Project	IEEE 802.16 Broadband Wireless Access Working Group < http://ieee802.org/16 >	
Title	Clarify the EAP based Authentication Procedure	
Date Submitted	2006-03-07	
Source(s)	Cancan Huang	chuang@ztesandiego.com
	Hong Chen	
	Jeff Qian	
	Mary Chion	
	Ling Xu	
	Sean Cai	
	ZTE

Re:	Contribution on comments to P802.16g-D1	
Abstract	In this contribution, we clarify the EAP based authentication procedure in Figure 477	
Purpose	Adoption

Clarification on EAP Based Authentication Procedure Diagram

Figure 477 --- EAP based Authentication Procedure

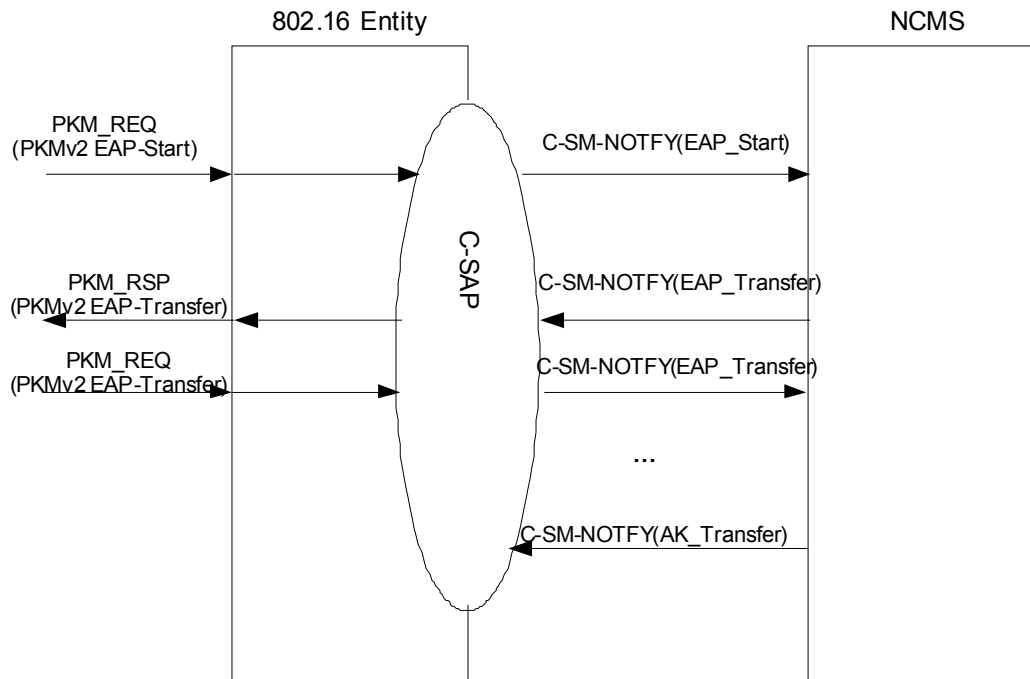
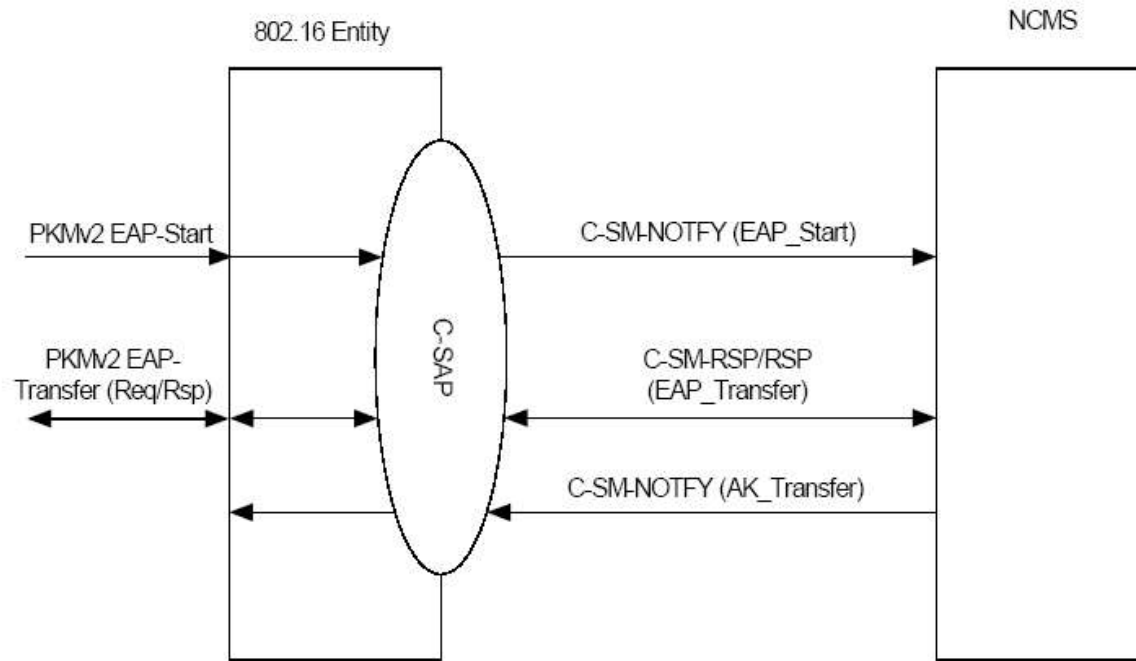
In Section 14.2.5.1 (EAP based authentication procedures), Figure 477, it is confused to use bi-direction arrow line to show interaction between 802.16 Entity and NCMS. It is hard to tell sequence of the call flow. Based on EAP specification, ~~the C_SM_REQ is sent from NCMS to 802.16 Entity. The 802.16 Entity will send C_SM_RSP in response to it. It is better to separate them by C_SM_NOTIFY~~, which will make the flow more accurate.

[Modify section 14.2.5.1, replace Figure 477 with the following figures]

This contribution clarifies the primitive diagrams by ~~separating-changing~~ the C_SM_REQ/RSP primitive ~~into two unidirectional arrow line~~ C_SM_NOTIFY.
